SAM G51 Series Family Silicon Errata and Data Sheet Clarification

The following typographic corrections and clarifications are to be noted for the latest version of the device data sheet (Atmel-11209D-ATARM-SAM-G51G-SAMG-51N-Datasheet_19-Nov-14).

4. Module: Transmitter Operations

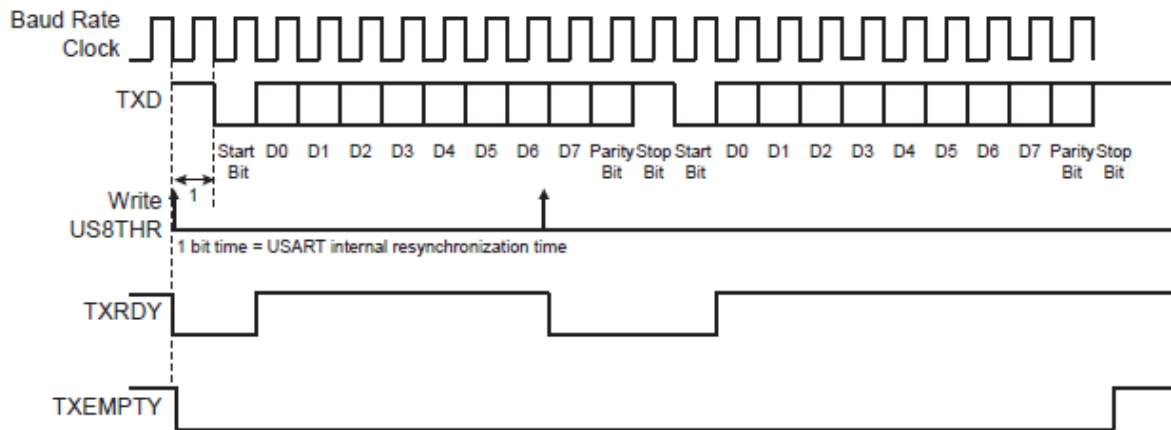
Figure 31-5 is incorrect and the corrected figure is as follows:
